# RENOVATION OF GALEHOUSE (A BUILDING), MCLEOD (S BUILDING), AND NATURAL SCIENCES (N BUILDING)

Cape Fear Community College Wilmington, North Carolina SCO #17-18154-01A; NCCCS #2352 BMG Project No. 2018023.00

#### **ADDENDUM NO. 1**

DRAWN BY: WPJ PROJ MGR: RDM E115A

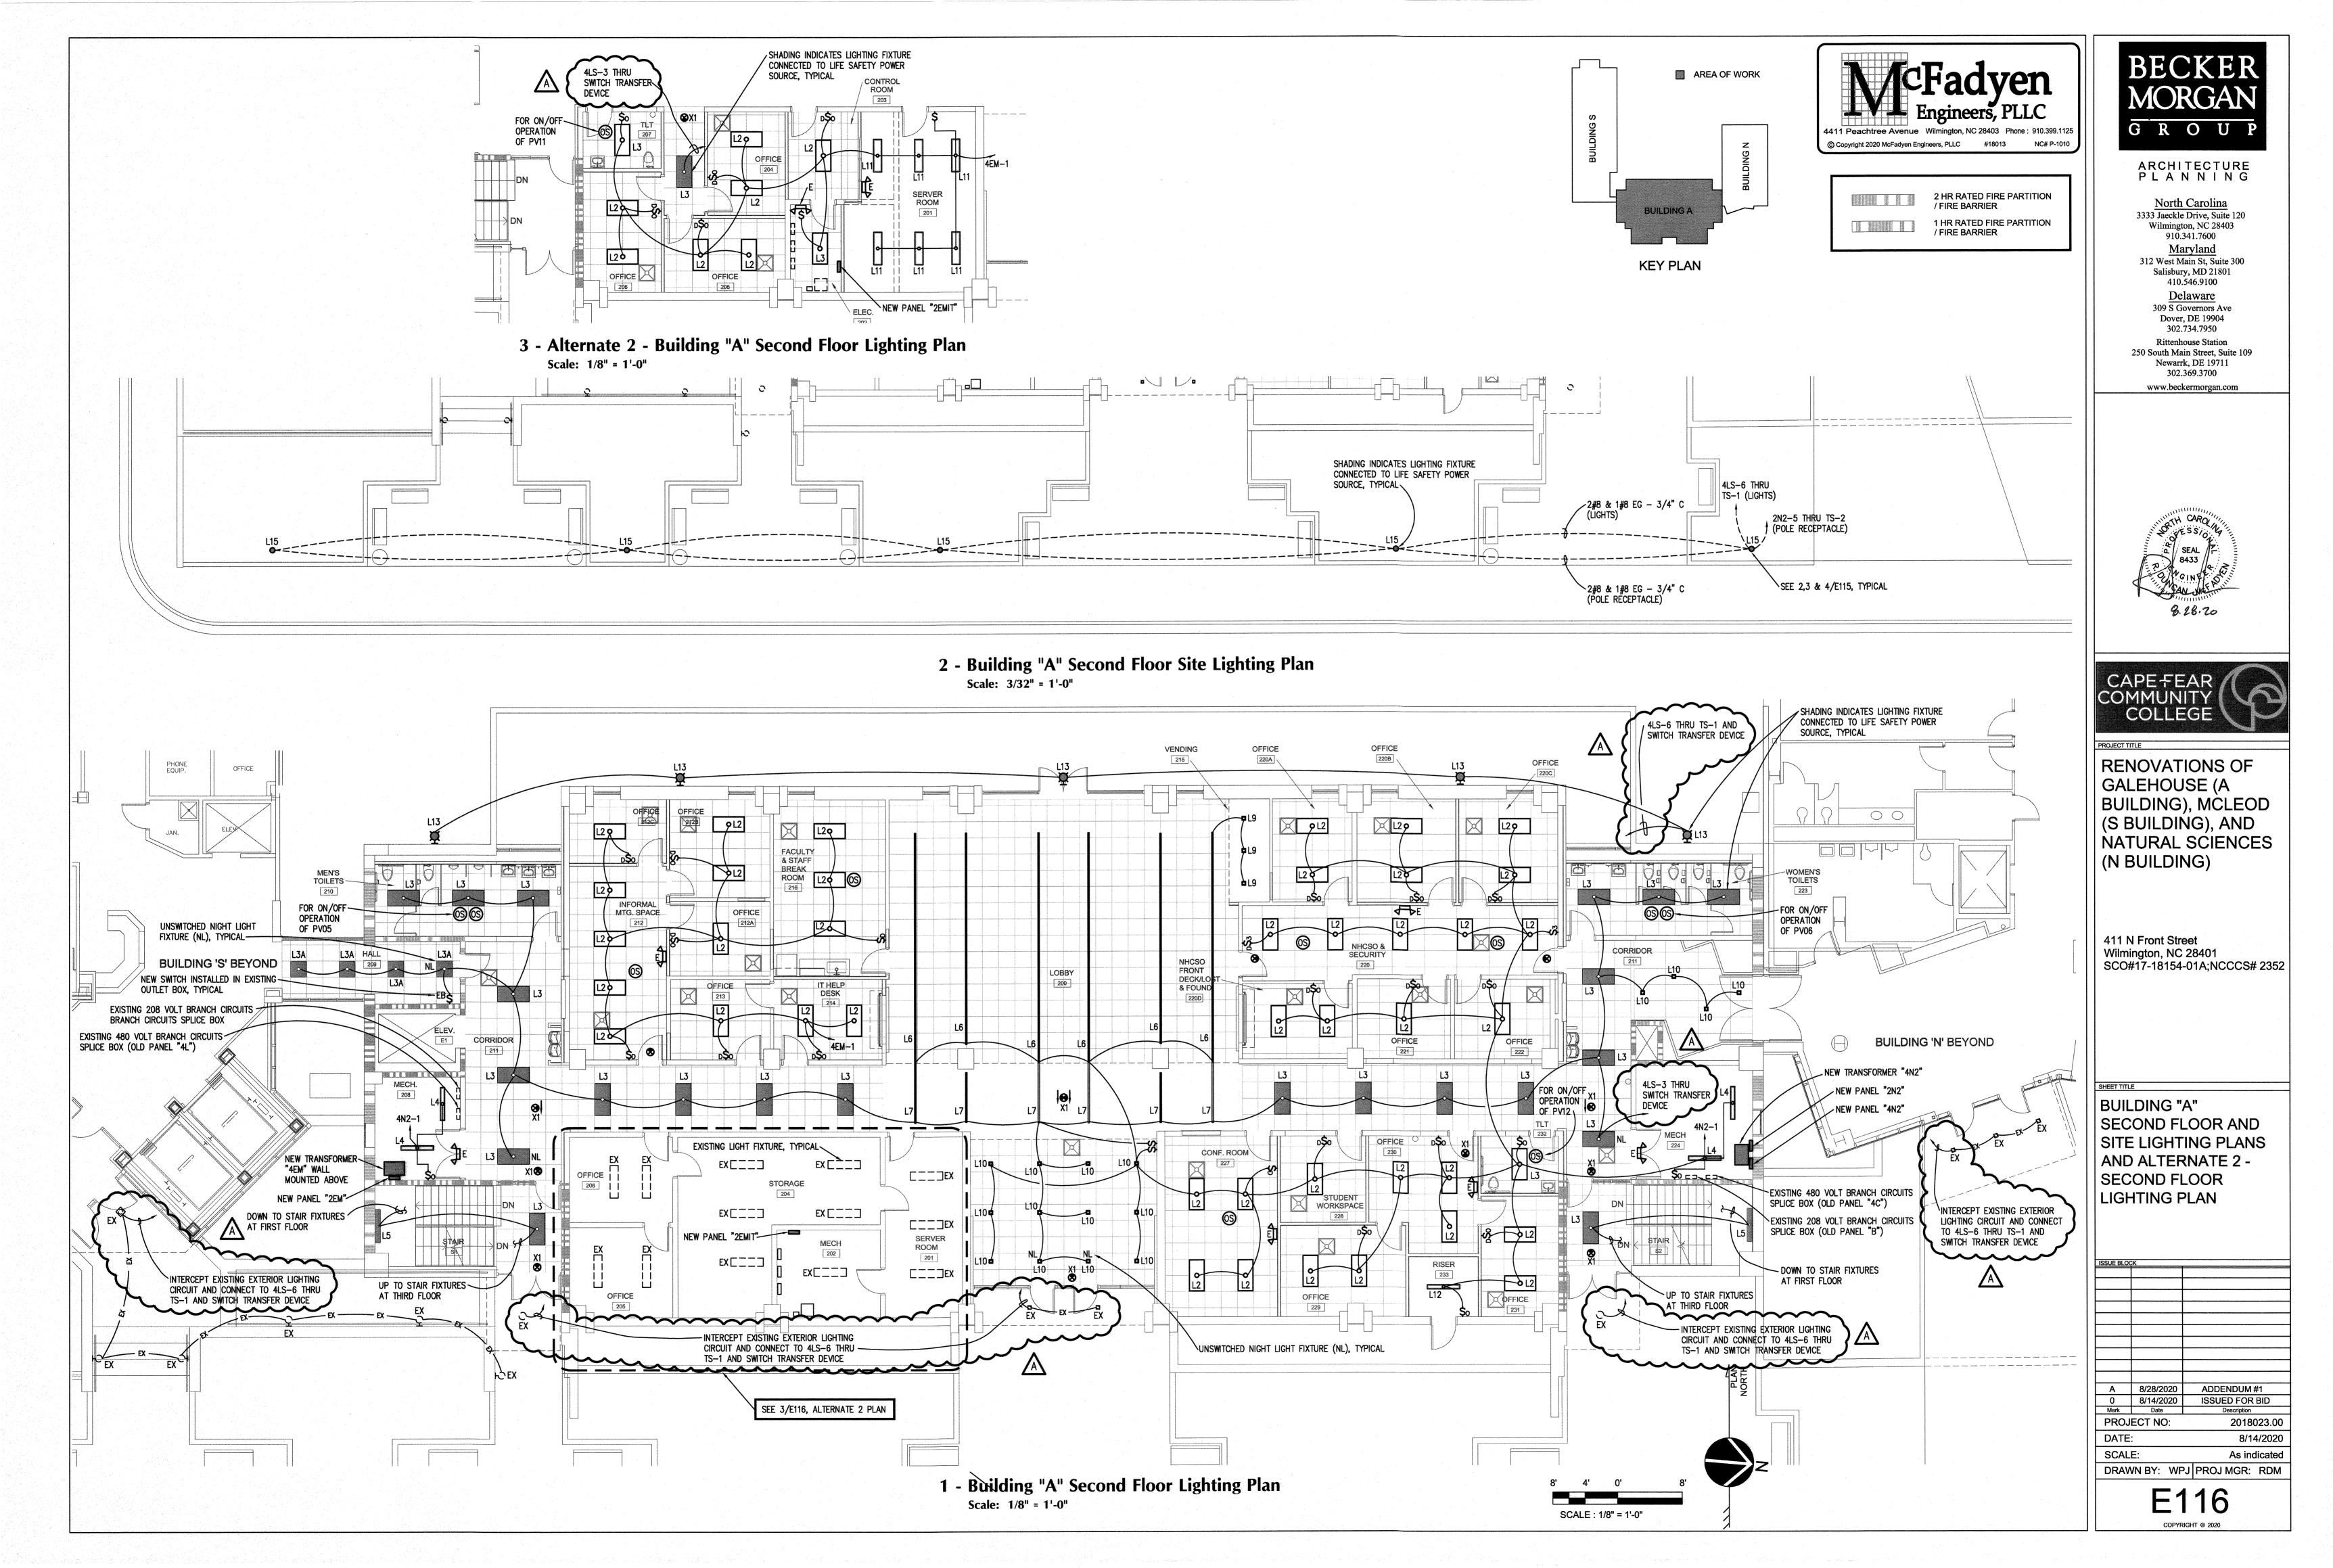
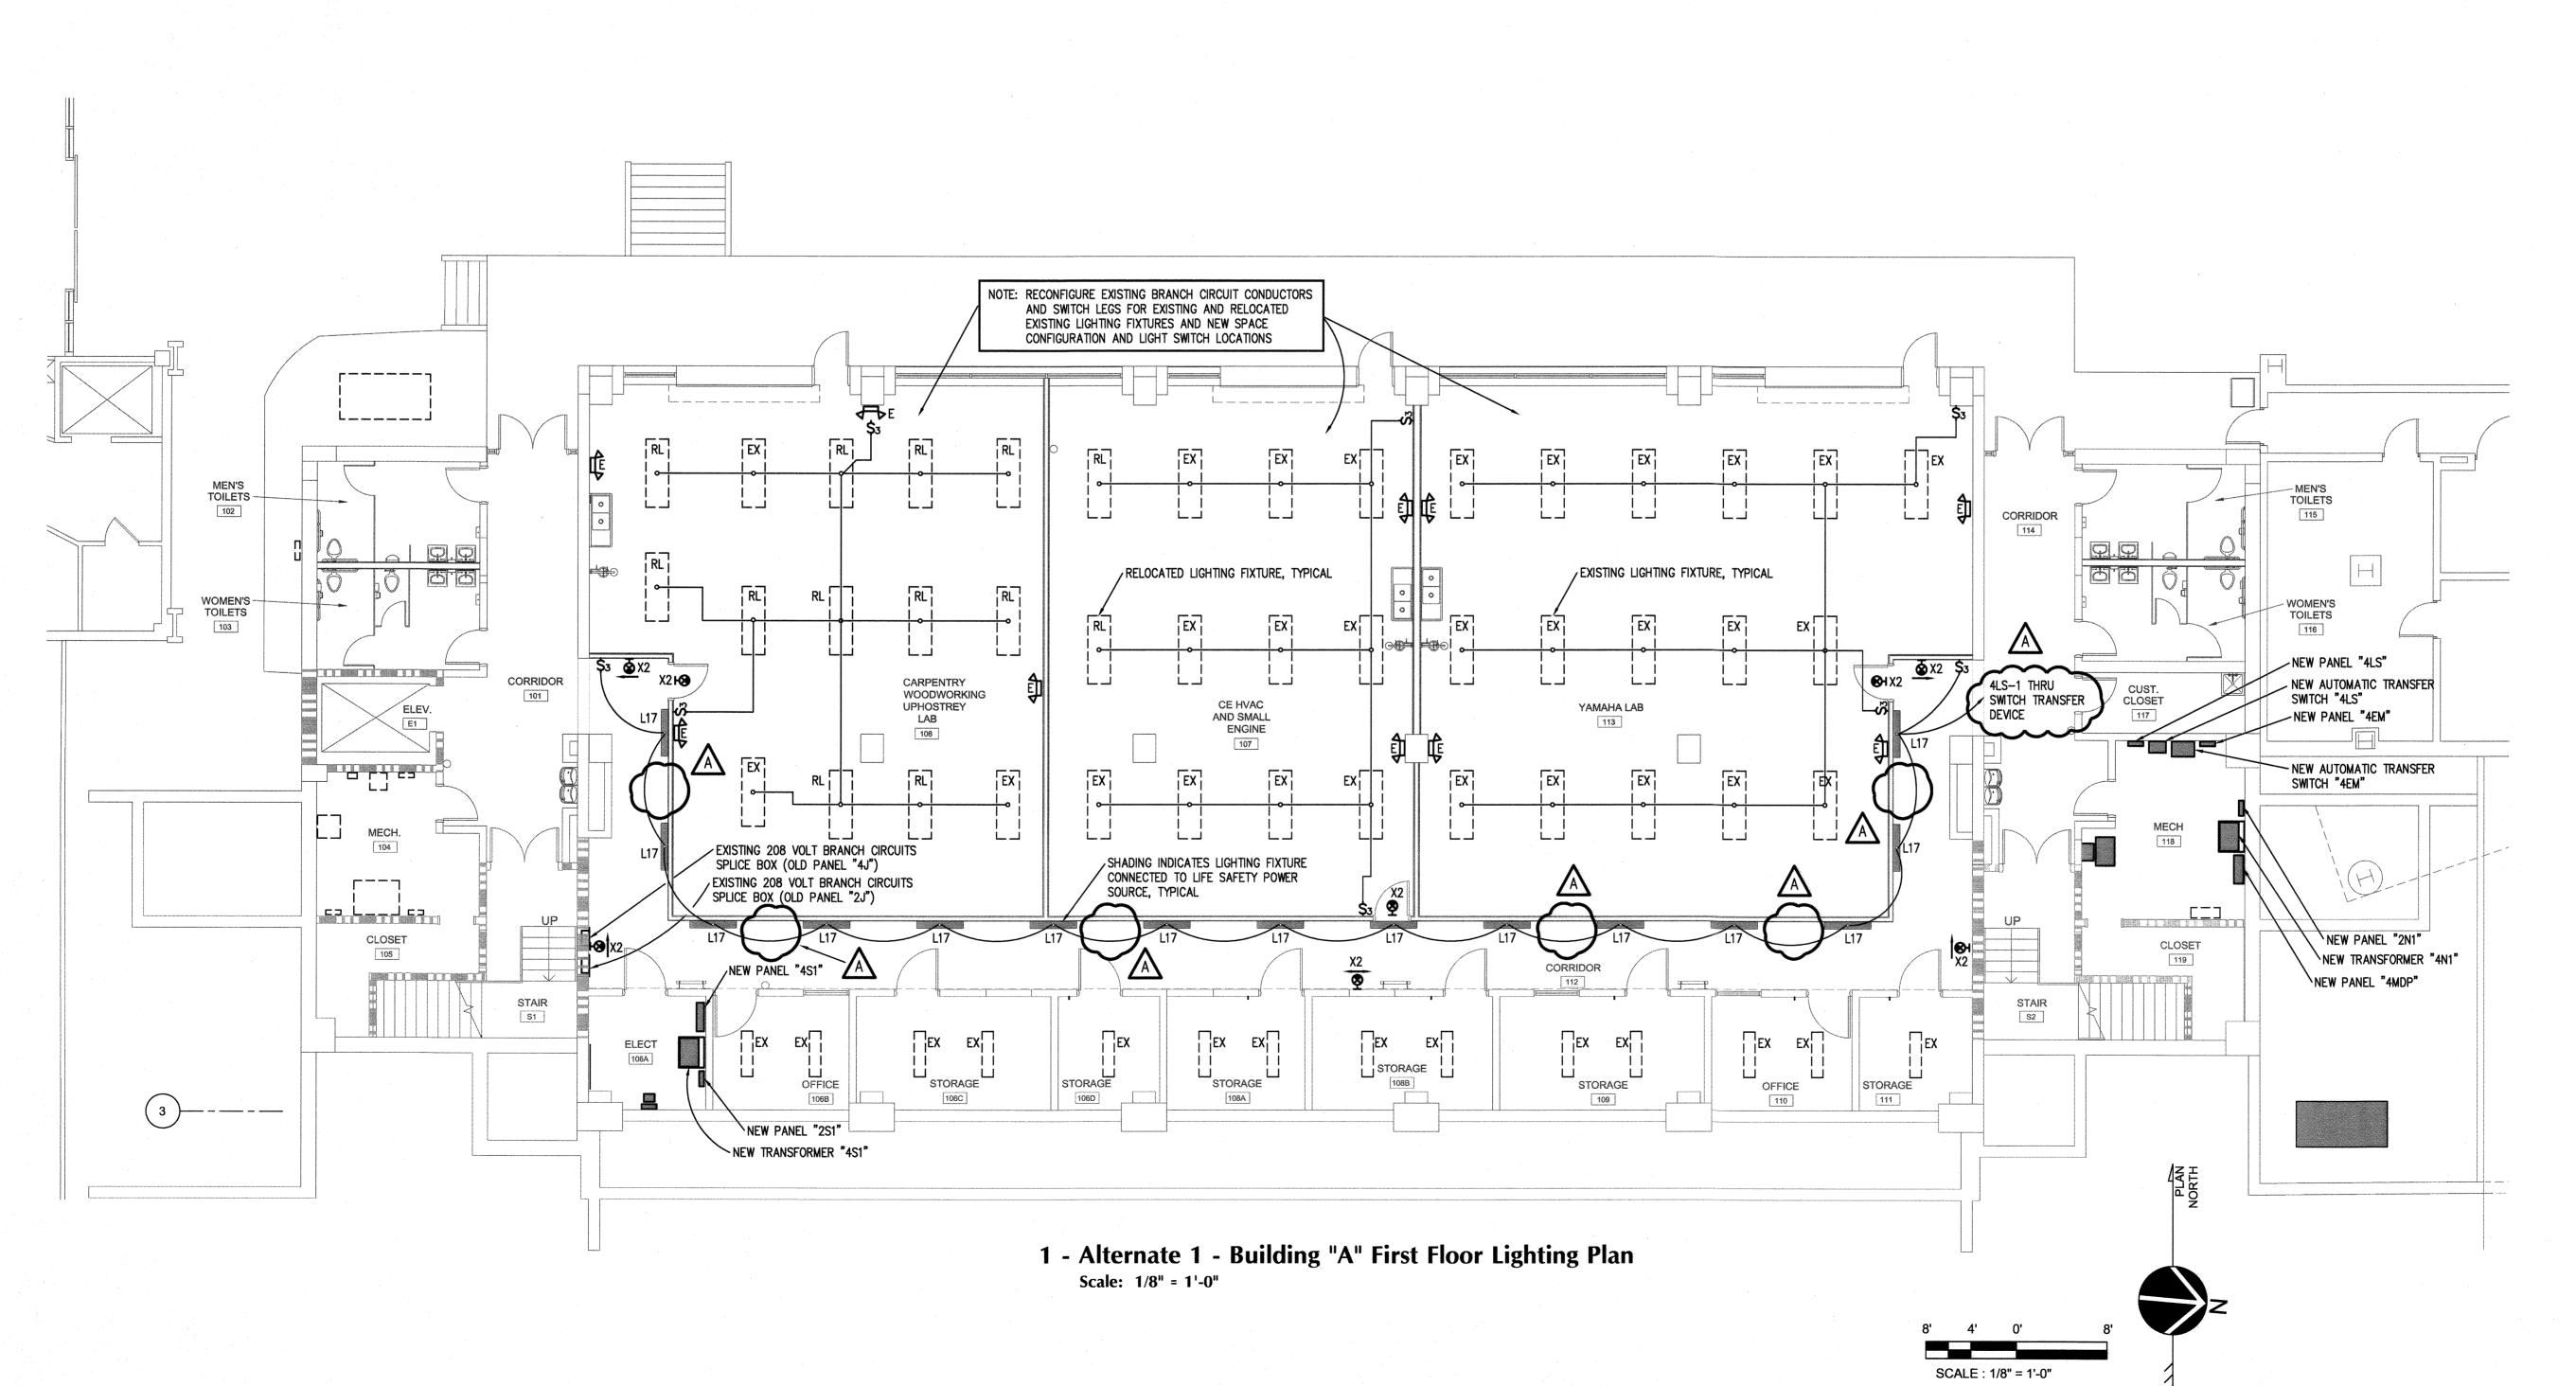
- t. E115 BUILDING "A" FIRST FLOOR LIGHTING PLAN AND SITE LIGHTING DETAILS: REVISED. Added switch transfer device locations.
- u. E115A ALTERNATE 1 BUILDING "A" FIRST FLOOR LIGHTING PLAN ND FIRST FLOOR MEZZANINE LIGHTING PLAN: REVISED. Add switch transfer device locations. Deleted Type "E" wall mounted emergency lighting fixtures in Corridor 112.

ALTERNATE 3 -BUILDING "A" THIRD FLOOR LIGHTING PLAN

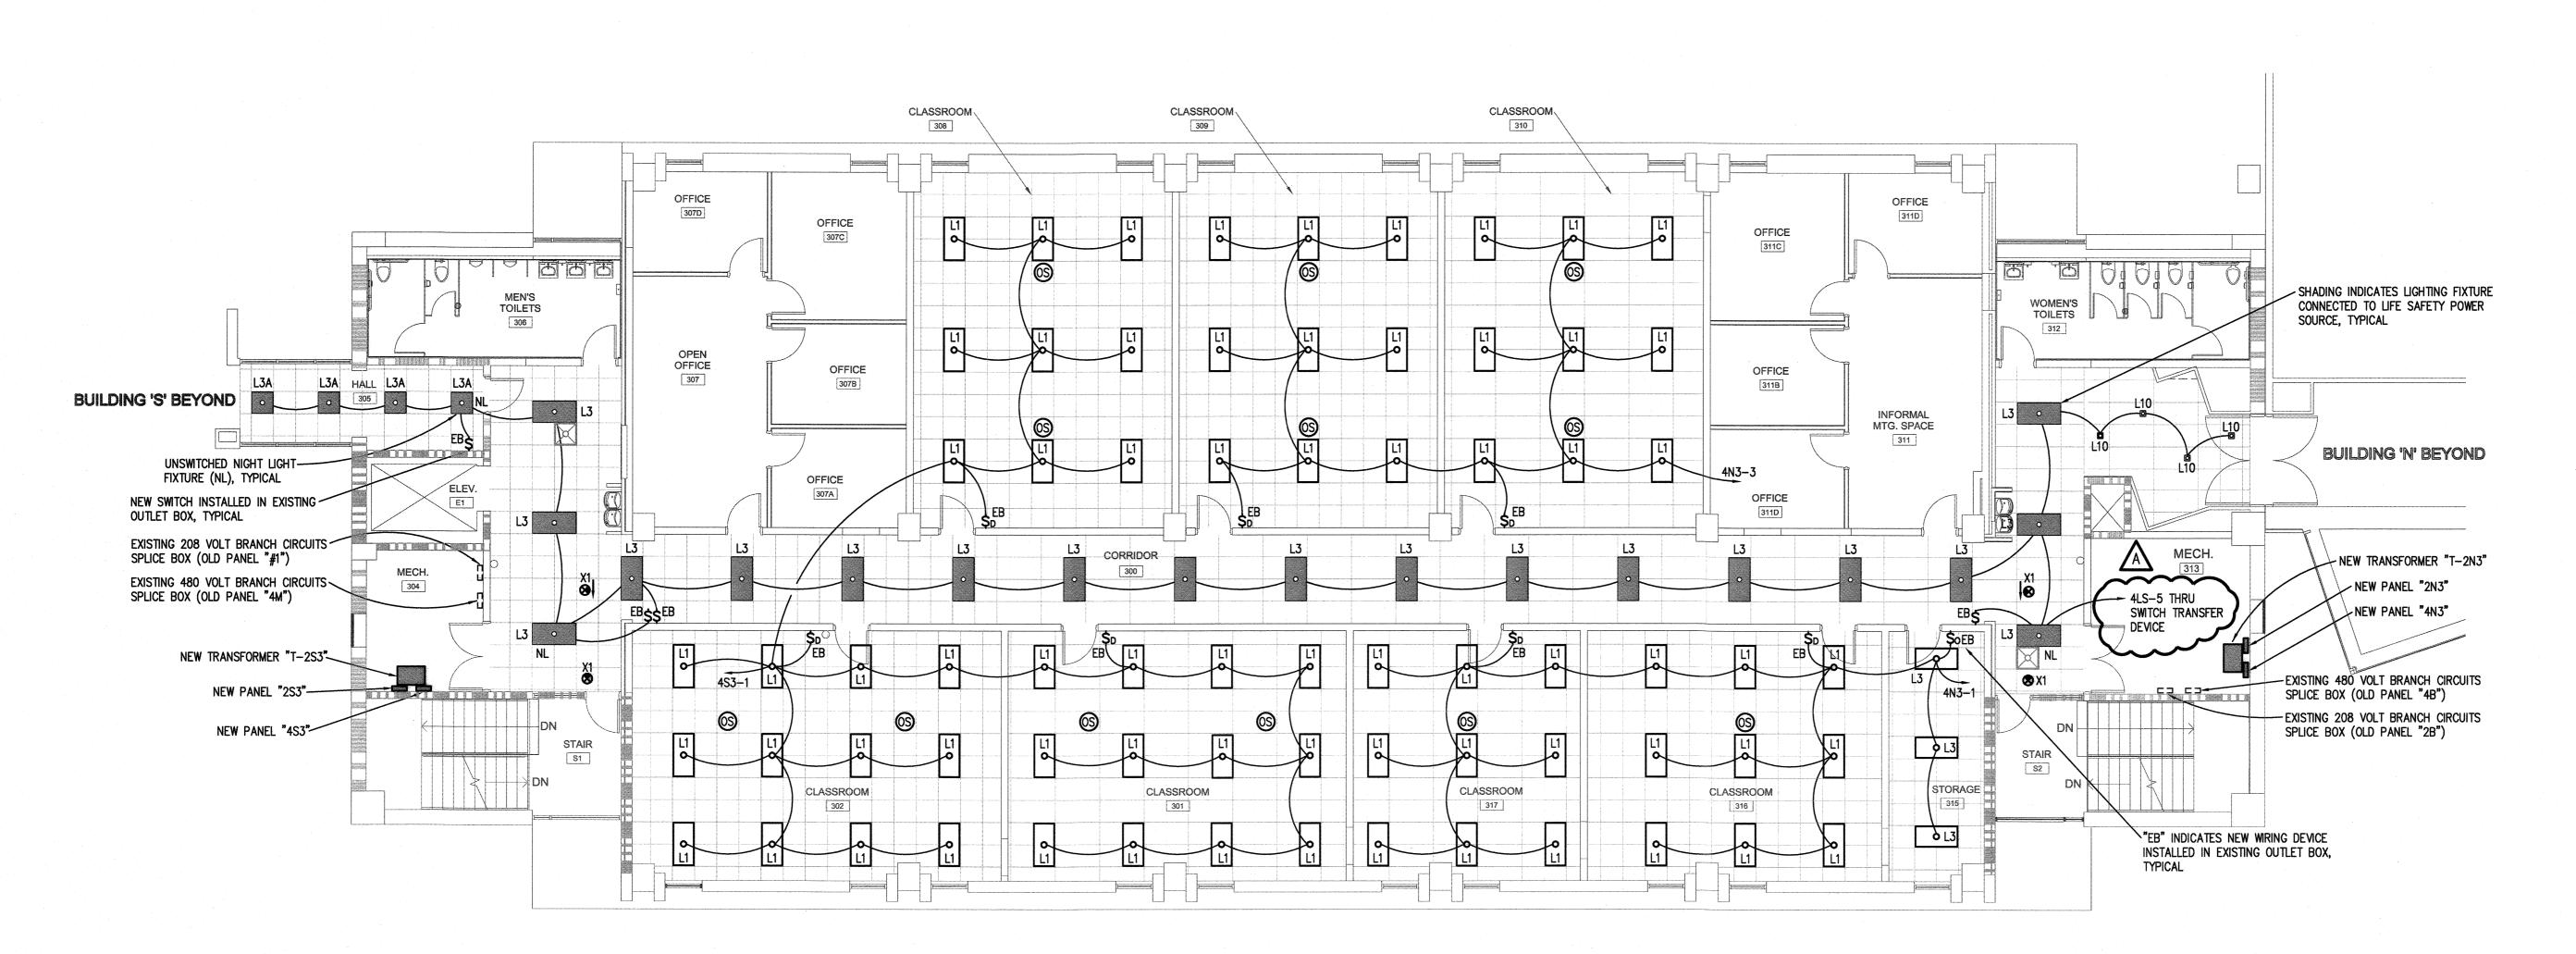
- w. E117A ALTERNATE 3 BUILDING "A" THIRD FLOOR LIGHTING PLAN: REVISED. Added switch transfer device locations.
- x. E118A ALTERNATE 4 BUILDING "A" FOURTH FLOOR LIGHTING PLAN: REVISED. Added switch transfer device locations.
